**LADERA
BUSINESS
PARK UNIT 1 -
CACTUS
PATCH PLAZA**

Project No.: PR-2021-005473

Application No.: SI-2021-00709

RE: Responses to June 09, 2021 DRB Comments

D1 CURB DETAIL
1" = 1'-0"

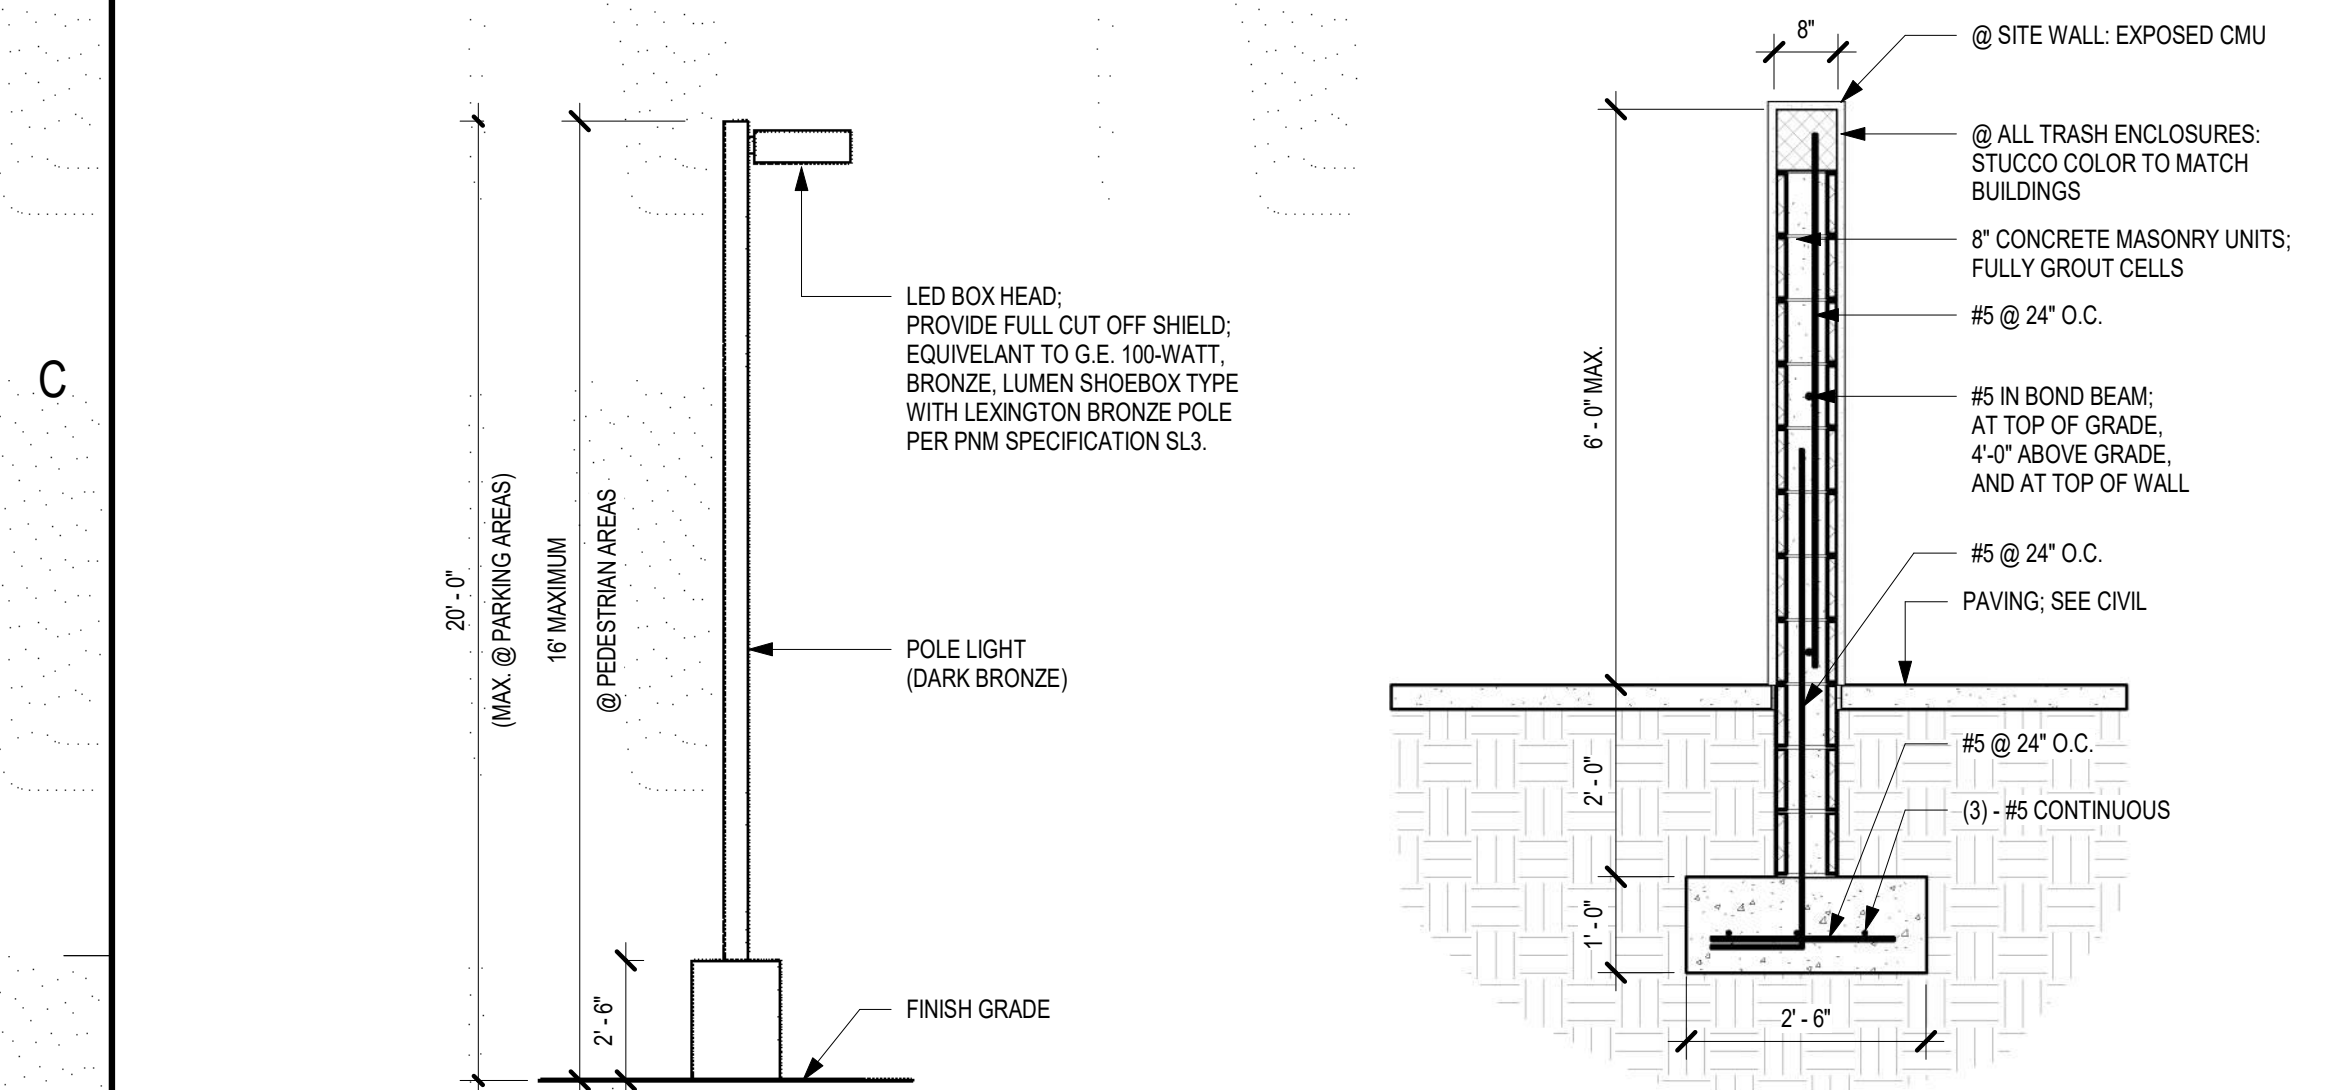
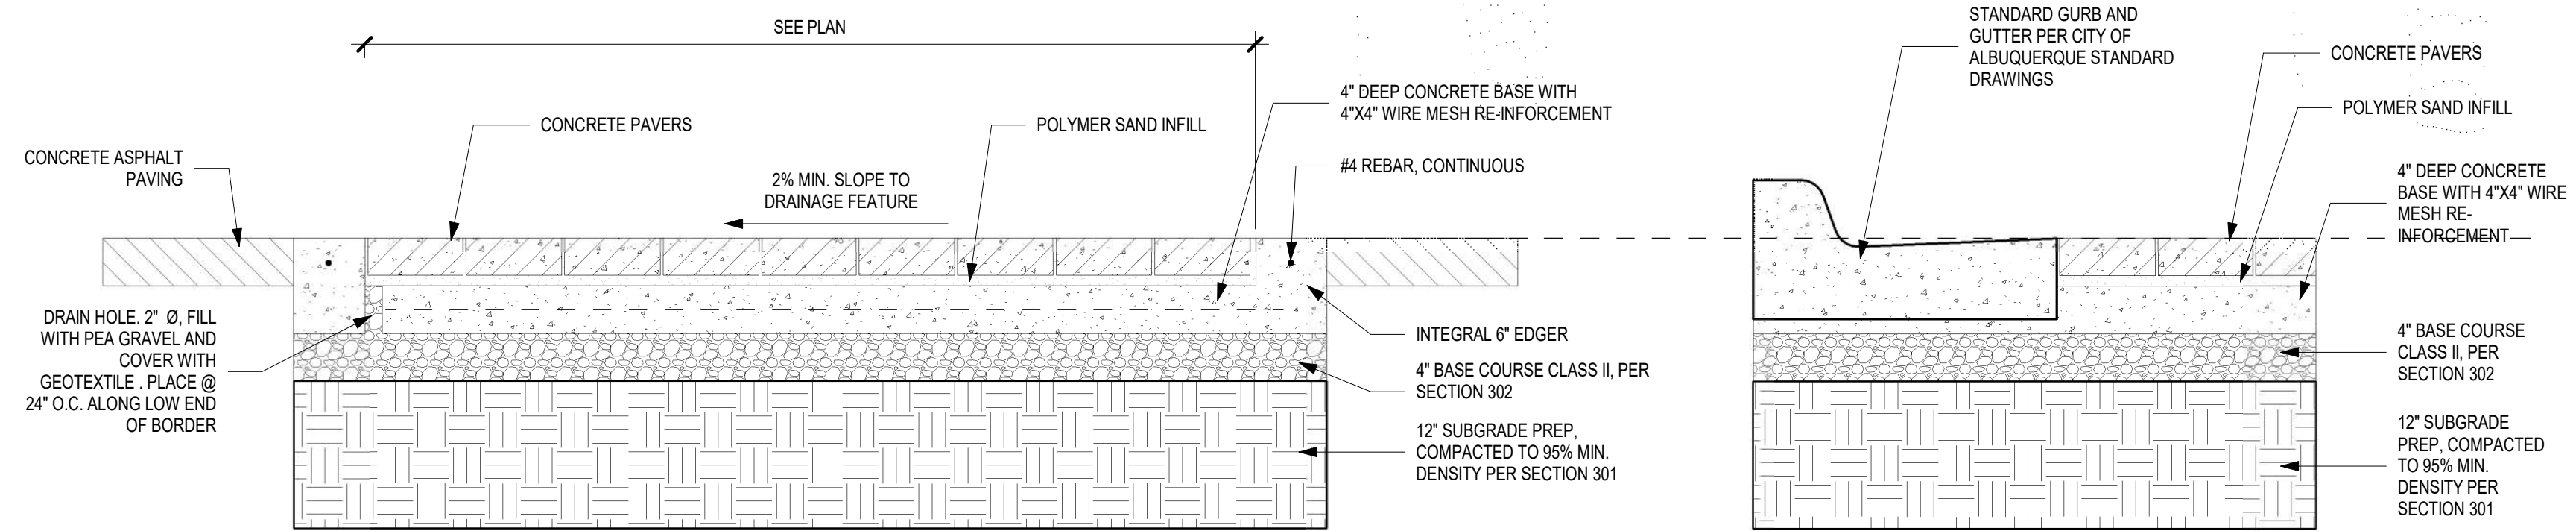
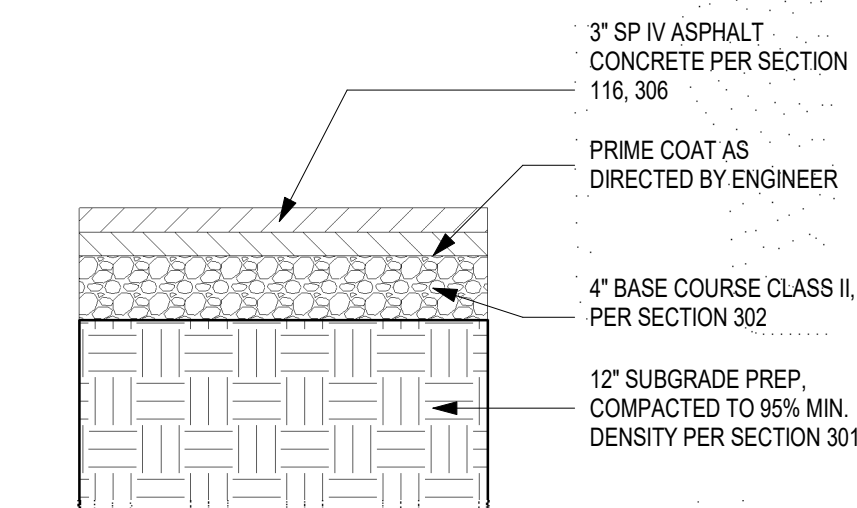
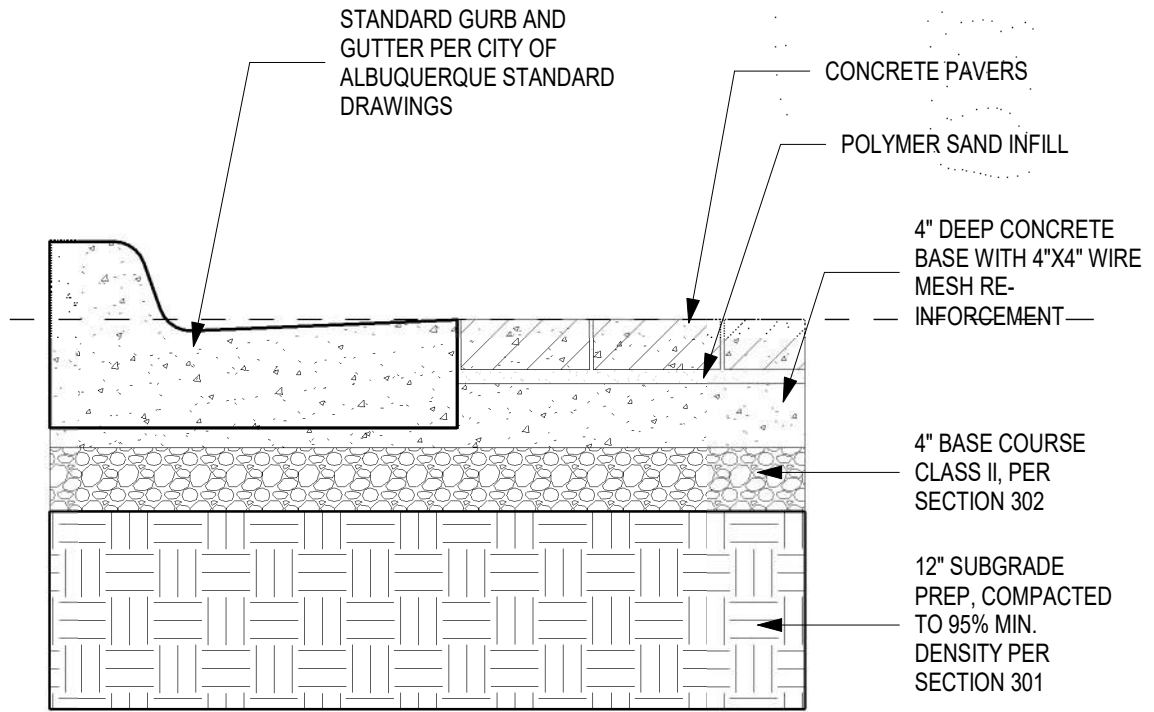
2. Call out paved surfaces on the plan, and call out curb to be 6" - 8" high. Provide curb detail. Call out all curb radii, following DPM standards.

[Provided](#)
